STAFF RECOMMENDATION

NCPC File No. MP 108

FORT LESLEY J. McNAIR
SUBAREA MASTER PLAN FOR THE NATIONAL DEFENSE UNIVERSITY
4th and P Streets, SW, Washington, DC

December 30, 2003

PREFERRED SUBAREA MASTER PLAN – PLAN 2

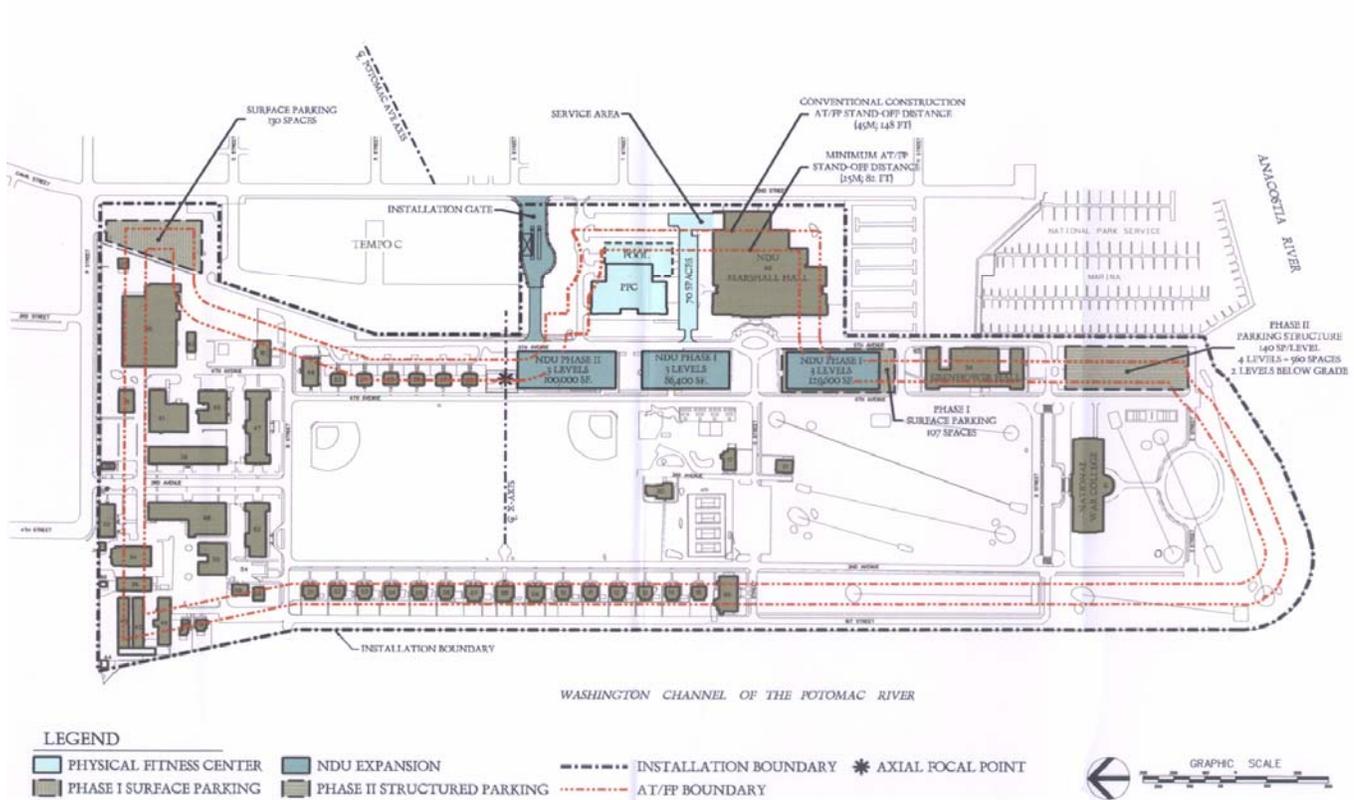
Finding that within the Subarea Master Plan most major issues are addressed by the Army, **staff fully supports the land acquisition initiative** and **recommends approval** of the submitted Subarea Master Plan, Plan 2, with conditions. Although the general basis of either of the development scenarios of the provided plans are generally acceptable, clearly Plan 2 is the stronger and more physically compatible plan that achieves urban design objectives which support aims of both the Commission and the District. Staff observes that Plan 2 presents:

- A stronger access location for a new gate in context with the City street grid and major view and access corridors of the L’Enfant Plan. The plan locates the gate at or near Potomac Avenue, SW. supporting the opportunity for varied visual treatment.

- The exterior and urban development forms and guiding concepts, which are adhered to as long-term implementation aids, unify the physical character of the campus and include force protection specifications.

- The buffer areas established in the plan configuration respect and maintain the historic district boundary along the northern and eastern edges of the post.

- Scales the massing of all new large facilities to the eastern core of the campus, allowing greater openness near the river shore environs.
- Presents a greater new “street presence” physical appearance compared to Plan 1 where the development assigns a more open space character to the perimeter of the Subarea Plan, thus making it less activated.

While encouraged by Plan 2, staff also believes the commitment to the TMP objectives of the Plan must be further pursued given the increase in parking specified in the Plan. The current submission does not demonstrate compliance with the commitment expressed by the Army in 1996 to adhere to the TMP objectives spelled out at that time. The plan provides 158 net spaces for employee-use by a potential 342 employees. To achieve the TMP objectives, the staff requests the Commission direct the Army to secure the duties of an Employee Transportation Coordinator (ETC) to implement the necessary TMP objectives at Fort McNair. The Army is reminded that the traffic management requirements for the post were formalized and approved by the National Capital Planning Commission in December 1996 and the Army at Fort McNair should demonstrate adherence to the Commission specified ratio of 1 parking space per three employees. And while clearly the need for student parking spaces drives the current deficit of parking (over 1,885 current students attend the NDU facilities at any one yearly term or session of instruction) the added parking in the Subarea Plan does not correctly account for employee parking in compliance with Commission requirements.

Approve Plan 2 for the Subarea Master Plan for Fort McNair located at 4th and P Streets, SW and **fully support** the Army's acquisition of the 8.5 acre site, know as Tempo C, as presented in the drawings and report titled, *Small Area Plan for the National Defense University / Physical Fitness Complex* dated July 2003, **except for** the identified surface parking spaces and parking structure locations.
